## SUMMARY OF CONCERNS IN RELATION TO THE PROPOSED NORTHCONNEX TUNNEL

**This is an objection to many aspects of the proposed NorthConnex tunnel.**

## SECTION A: THE CONNECTIVITY OF NORTHCONNEX SOUTHERN VENTILATION FACILITY AT THE SOUTHERN INTERCHANGE, THE SOUTHBOUND TUNNEL IN PARTICULAR

Figure 5-17 Motorway operations complex

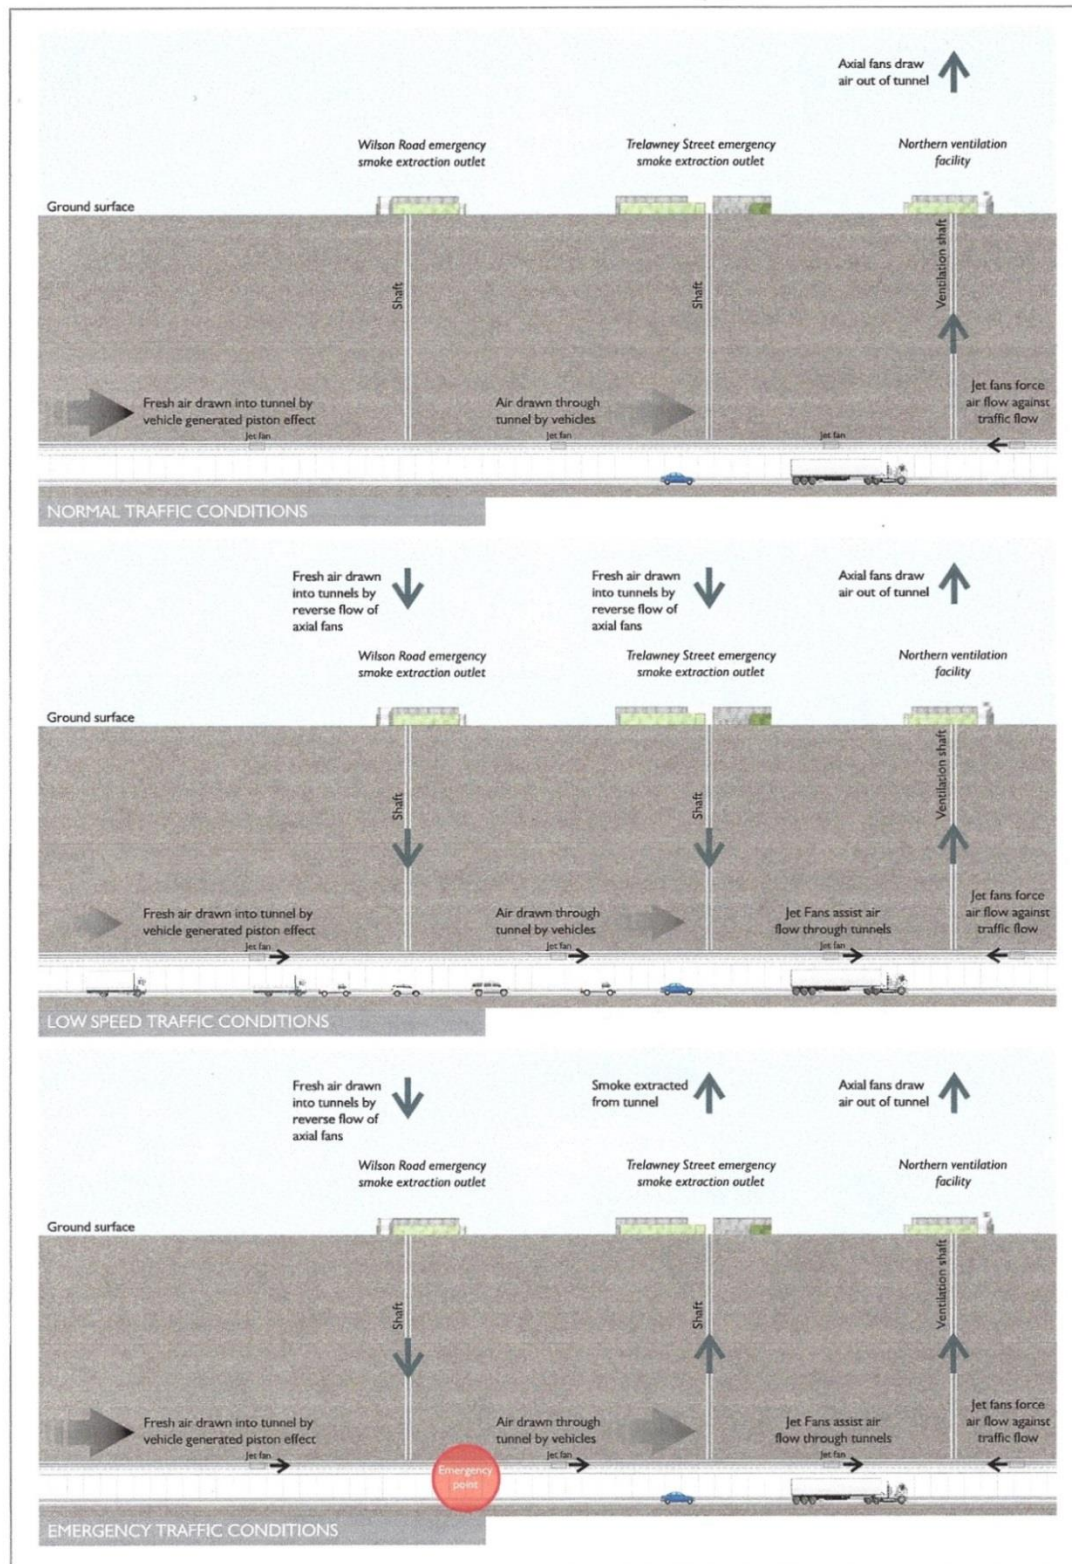
EIS Page 111, *Figure 5-17 Motorway operations complex*

*Page 8 below* there is no indication of how the ventilation facility will be connected to either the northbound or southbound tunnel, nor is there any indication of how the southbound exit portal onto Pennant Hills Road or the south-west exit portal onto the M2 will be connected.

- Diagrams need to be provided showing the inter-relation between the shaft, the ventilation outlet and the motorway operations centre with a clear description of what is to be constructed and how it will operate.
- The community needs irrefutable evidence that the polluted air from the southbound tunnel exit portals will not be allowed to flow like an invisible sewer through West Pennant Hills, North Rocks, Carlingford and Beecroft.

Figure 5-38 Indicative southern interchange construction compound

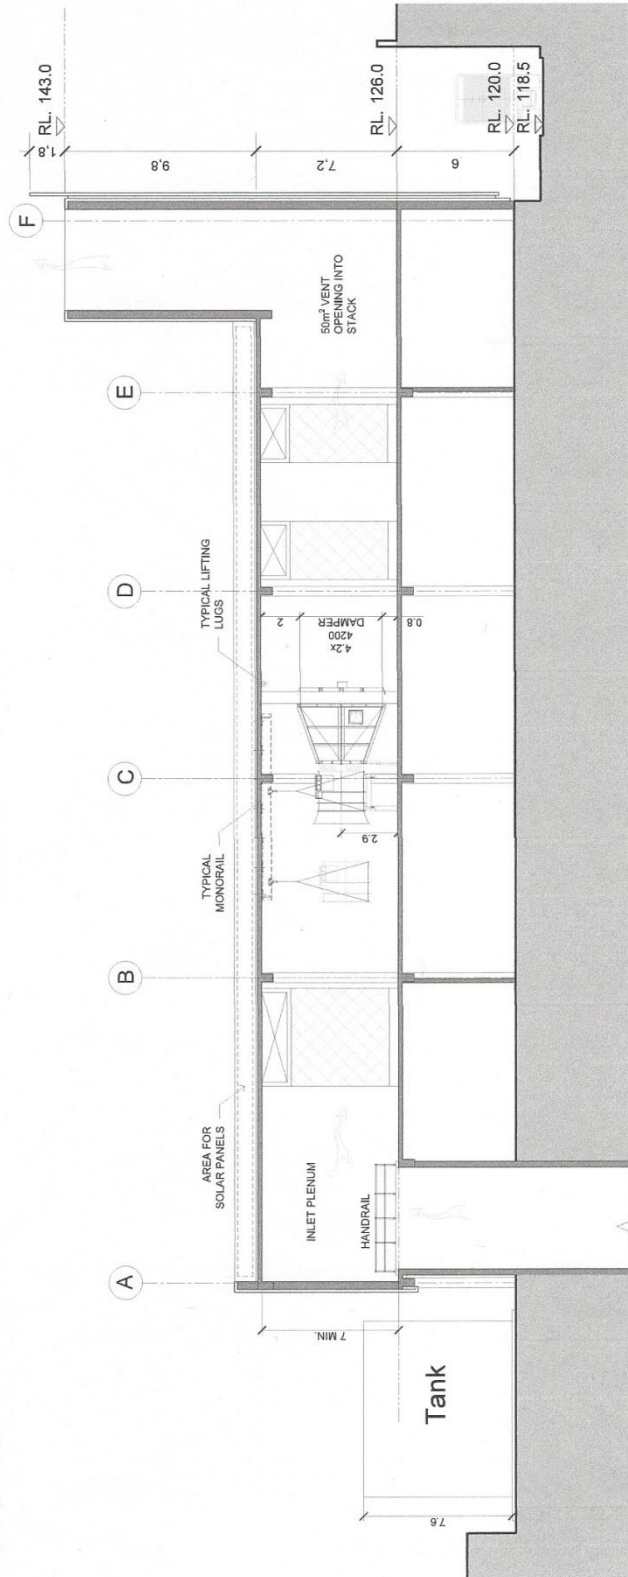
3. EIS Page 189 *Figure 5-38 Indicative southern interchange construction compound* *Page 9 below*

It is ominous that the southern ventilation facility and shaft are completely absent from Figure 5-38.

MOTORWAY OPERATIONS COMPLEX - SOUTHERN VENTILATION FACILITY - SECTIONS  
M1-M2-5000-DR-JD-0525

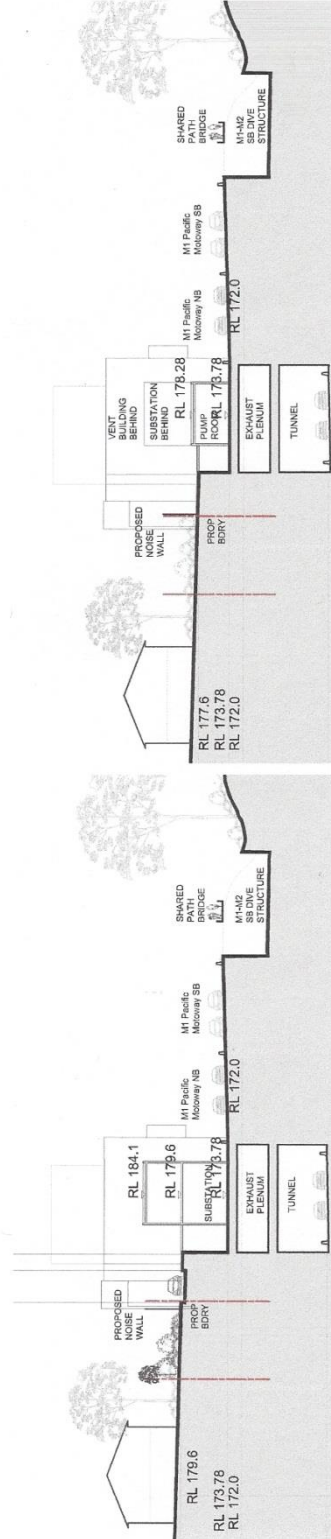
5. *EIS Volume 4, Technical working papers - Urban Design, 6.0 Operational Ancillary Facilities*  
EIS Page 99 there is the diagram "Motorway Operations Complex – Southern Ventilation Facility – sections. *Page 10 below* The diagram has the cryptic label "Connection to tunnel TBC". What does TBC stand for? To be considered? Why is tunnel singular? Which tunnel is the diagram referring to northbound or southbound? There is no diagram showing any connection from the Southern Interchange ventilation facility to either the northbound or the southbound tunnel in any way AND YET ....
